Leigh Creek Energy

Environmental Impact Report

ISG Demonstration Plant

Document	Leigh Creek Energy Environmental Impact Report ISG Demonstration Plant
Date	3 April 2018
Prepared by	Michelle Waters, Leigh Creek Energy Limited Stephen Milne, JBS&G Australia Pty Ltd

Figure 4-12: Geological type section for the demonstration plant location

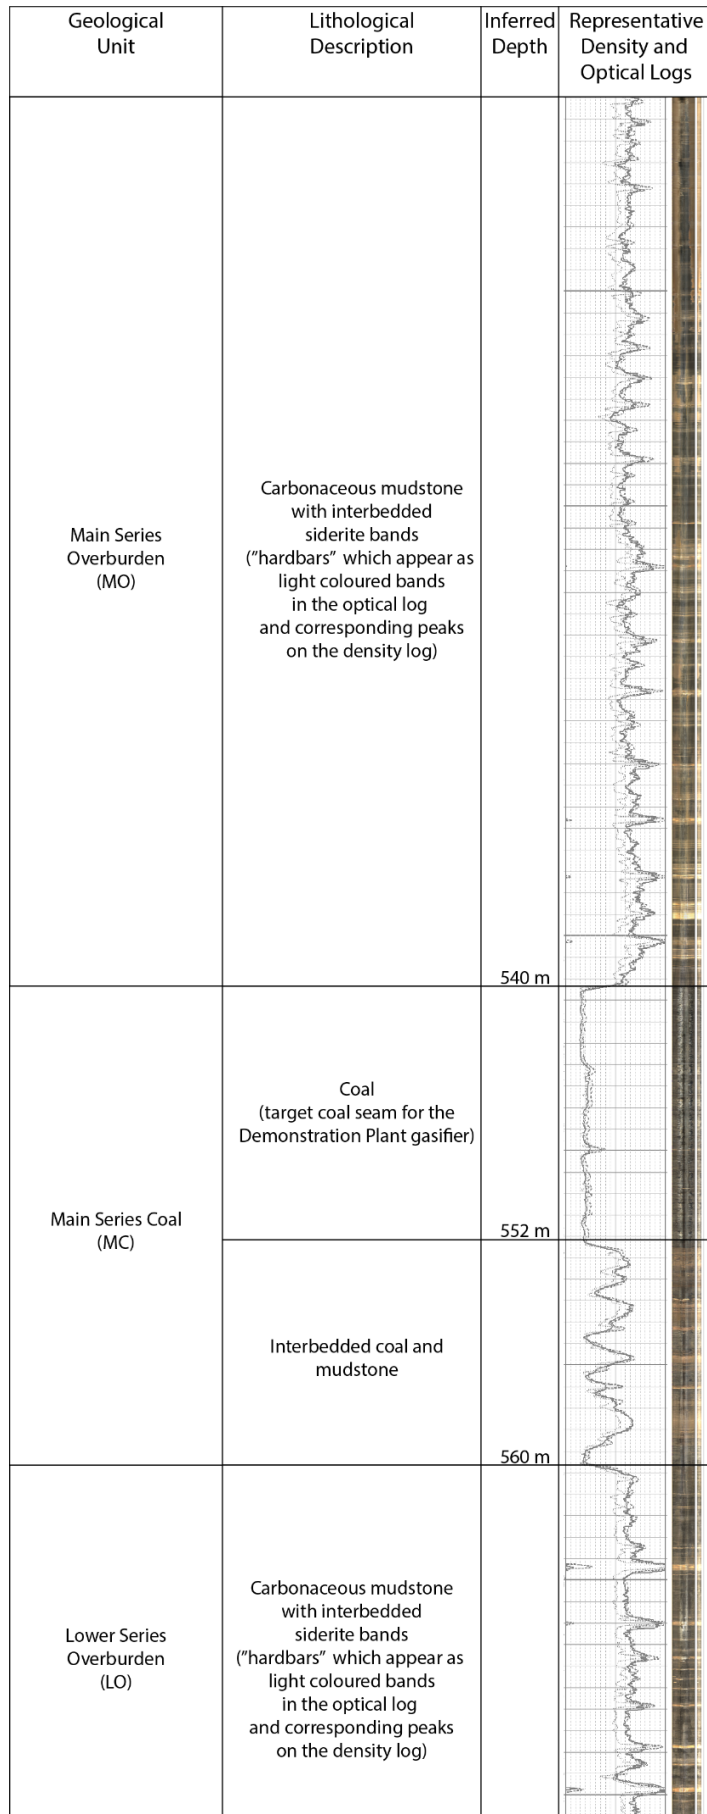
43	EPA	EIR Section 4.6.2, p.73	Groundwater assessment	Where is the location of the geological type section?	Noted. Figure 4-12 is based on the geology encountered in LCK drill hole Playford 5.
44	EPA	EIR Section 4.6.4, p.76	Groundwater assessment	Siting of the gasifier paragraph – '...at least 100m from faults...' – Is this distance 100m from edge of the fault/fracture zones, or from the centre of the fault/fracture zone?	The distance is measured from the outer extent of the gasifier and the fault boundary closest to the gasifier
45	EPA	EIR Section 4.7.1.3, p.81, Table 4-5 (and Appendix A, p.10, Table 2.1)	Groundwater assessment	This table should state the water quality categories as detailed in the <i>Environment Protection (Water Quality) Policy 2015</i> .	The Environment Protection (Water Quality) Policy indicates the following environmental values for underground waters: • TDS < 1200 mg/l – drinking water, irrigation, livestock • TDS > 1200 and less 3000 mg/l – irrigation, livestock • TDS >3000 and less 13000 mg/l – livestock The policy indicates higher salinities can potentially be used for livestock. However, in the EIR, LCK sought to put into context to the reader and interested stakeholders that the high salinities encountered on site would not be suitable for maintaining the good health of stock, particularly cattle. It is noted that pastoralists in the region do not use groundwater with salinities encountered at the site for stock water.

Figure 4-14: Detailed cross section through demonstration plant gasifier

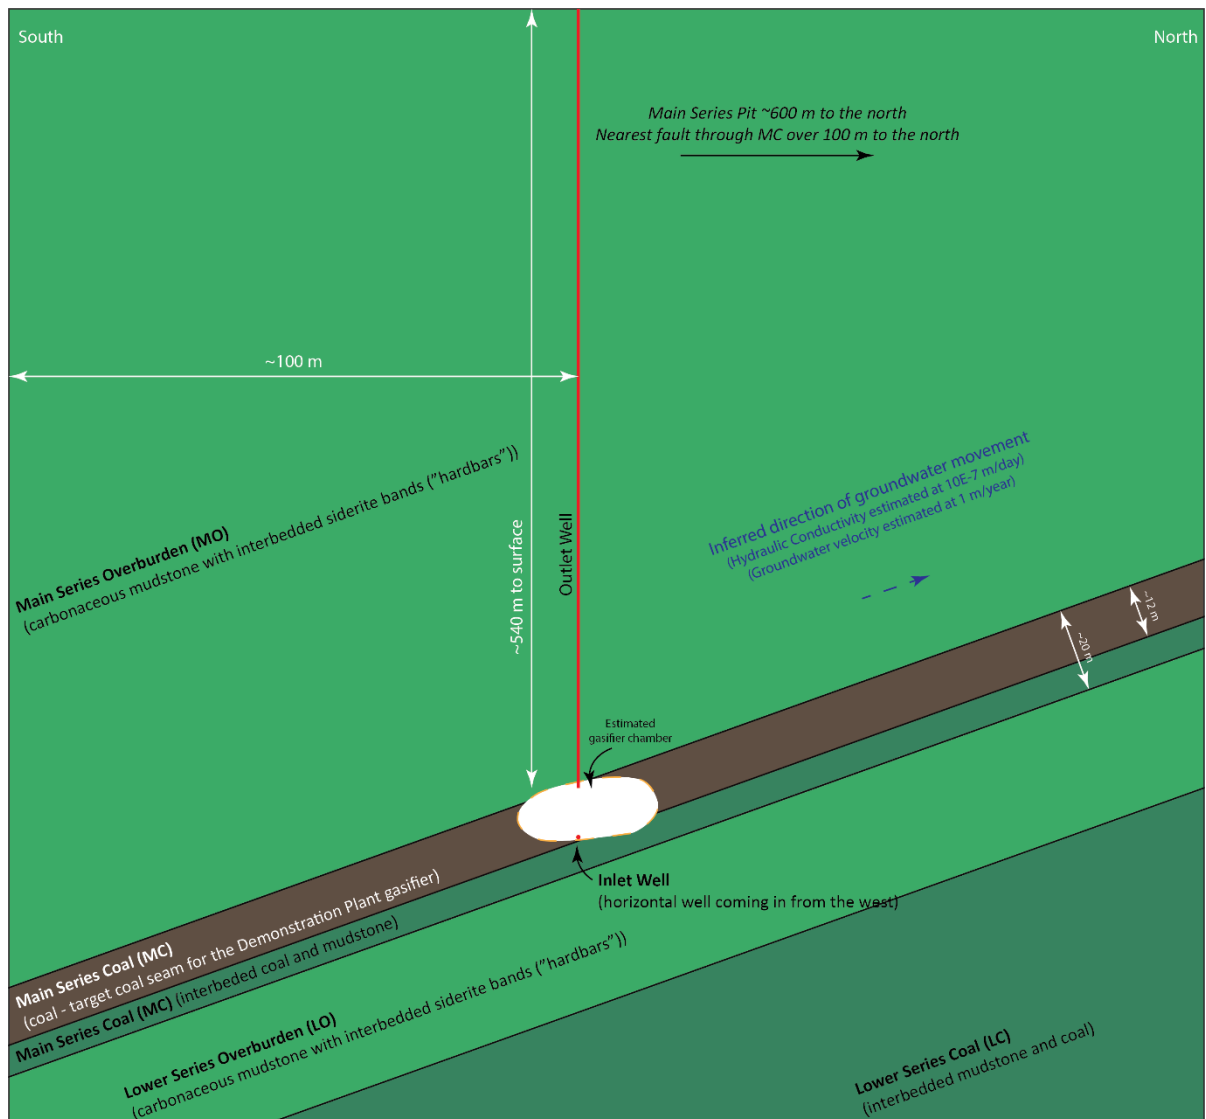
#	Agency	EIR/SEO Reference	Topic/ Issue	Issue Raised in Submission	Response
108	DEWNR Sci	EIR Figure 4.14. p.75	Hydraulic conductivity	The figures for hydraulic conductivity and groundwater velocity are for different parameter scenario. Refer to section 5.1.1 in Appendix A. A hydraulic conductivity of 10^{-7} corresponds to a velocity of mms/yr whilst a hydraulic conductivity of 10^{-3} corresponds to a velocity of m/yr. This is repeated on a number of figures in the report.	Noted. DEWNR's understanding is correct. Hydraulic conductivity is reported in Appendix A to range between 10-3 and 10-7 m/day based on different testing methods. AWE reports that 10-7 m/day is more representative of actual formation conditions as it is based on groundwater recovery into wells from the formation. This corresponds to a calculated groundwater velocity in the order of mm/year. To assess groundwater risks a groundwater velocity of 1 m/year was used (based on the hydraulic conductivity of 10-3 m/d) as this faster rate of movement introduces an additional margin of safety. LCK notes the text in the identified figures is not clear but also that left written as is does not change the conclusions of the AWE report or the EIR.

FIGURE 4.5 GROUNDWATER HEAD PRESSURE HYDROGRAPHS FROM INSTALLED VIBRATING WIRE PIEZOMETERS

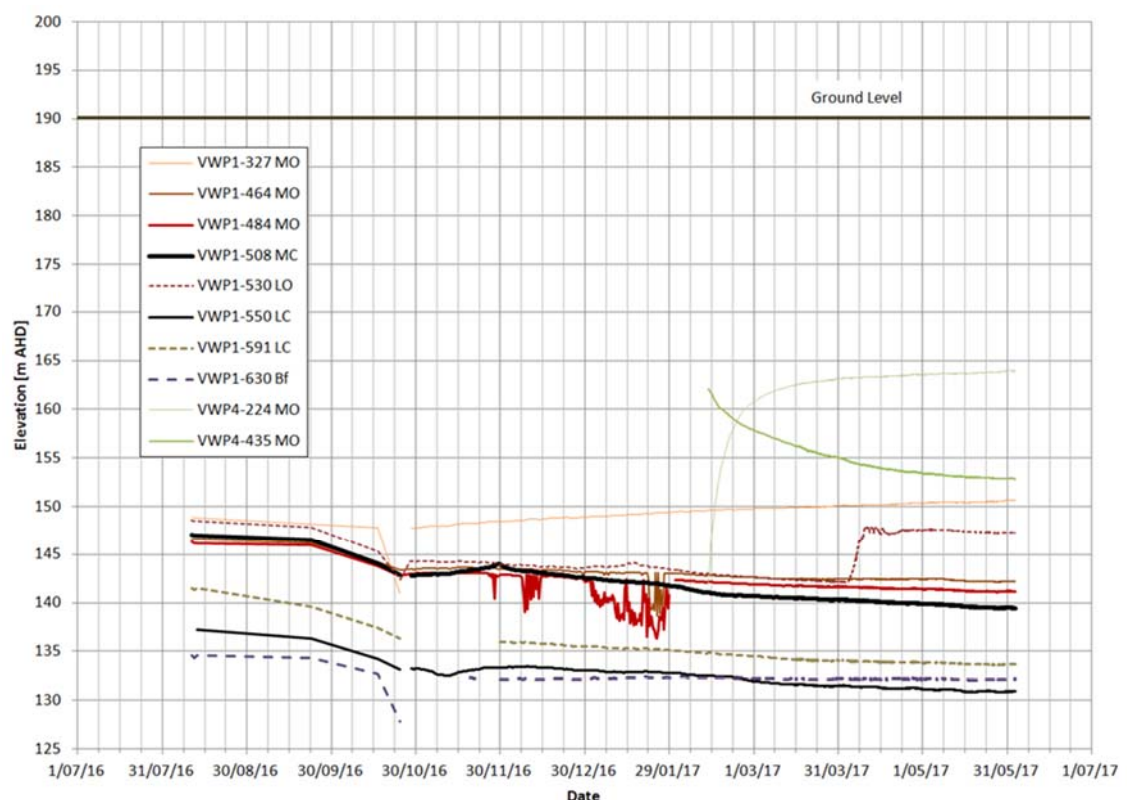
124	DEWNR Sci	Appendix A Section 4.4, p.22	Swabbing'	Details of the 'swabbing' sampling technique are to be provided. This could be included in the groundwater monitoring plan	Refer to Submission 61.
125	DEWNR Sci	Appendix A Figure 4.5, p.24	VWP data	Comments are required to explain the anomalies (sudden changes in trends) in the VWP data.	No detailed review of this VWP data has yet to be undertaken. LCK drilling activities and mine closure activities may explain these anomalies.
126	DEWNR Sci	Appendix A Figure 4.5, p.24	VWP data	Are these the same VWPs displayed in figure 4.1? Different VWP naming convention has been used.	Yes. The difference in naming convention between figures is noted.
127	DEWNR Sci	Appendix A Section 4.5, p.25, para 2	Salinity values	The last sentence states that a salinity profile needs to be run on well 3967, yet a salinity range is reported for the well in the start of section 4.6. Are these values suitable for calculating an accurate pressure at the monitoring depth? LCK to comment.	No vertical salinity profile in the well has been obtained. Salinity reading have been collected during water level gauging events.

FIGURE 4.6 SCHEMATIC CROSS SECTION OF THE BASELINE GROUNDWATER PRESSURE GRADIENT FOR THE DEMONSTRATION PLANT (NOTE: “10E-7” IS THE SAME AS “1 X 10⁻⁷”)

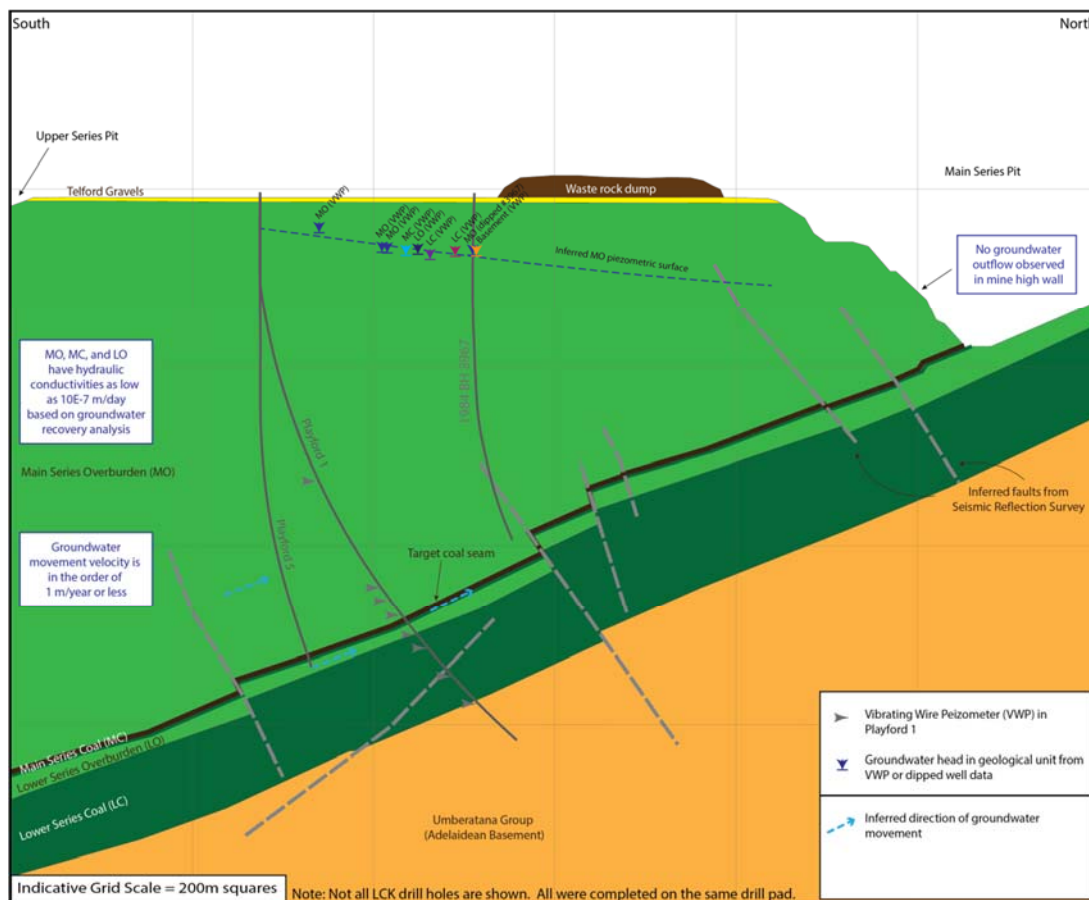
120	DEWNR Sci	Appendix A Section 1 Exec Summary p.3, para 5	foreseeable future'	Use of the term foreseeable future. This is subject to misinterpretation and it is preferred if a year range is presented. In paragraph 6 it is stated that it is expected to take between 2 to 20 years for groundwater to reach equilibrium with the surrounding strata.	Refer to response to submission 58.
121	DEWNR Sci	Appendix A Figure 3.6, p.16		To consider displaying drainage lines to statement that drainage is to the north and east	Drainage lines, catchment boundaries and surface water flow direction are included in Figure 4.24 of the EIR.
122	DEWNR Sci	Appendix A Section 3.2, p.16, para 1	Surface water ponding	Ponding of surface water could also have recharge the shallower Telford Gravels	Noted
123	DEWNR Sci	Appendix A Section 4.3, p.22	Figure 4.3	Some discussion is required explaining the interpretation of Figure 4.3.	Fig. 4.3 illustrates a 2016 interpretation by Velseis (contracted by LCK) of seismic reflection data collected by ETSA in 1978. The drill holes completed by LCK at the time of preparation of the EIR were sited on this seismic line to provide direct geological data to aid in this interpretation and development of the schematic geological cross section (Fig. 4.6).
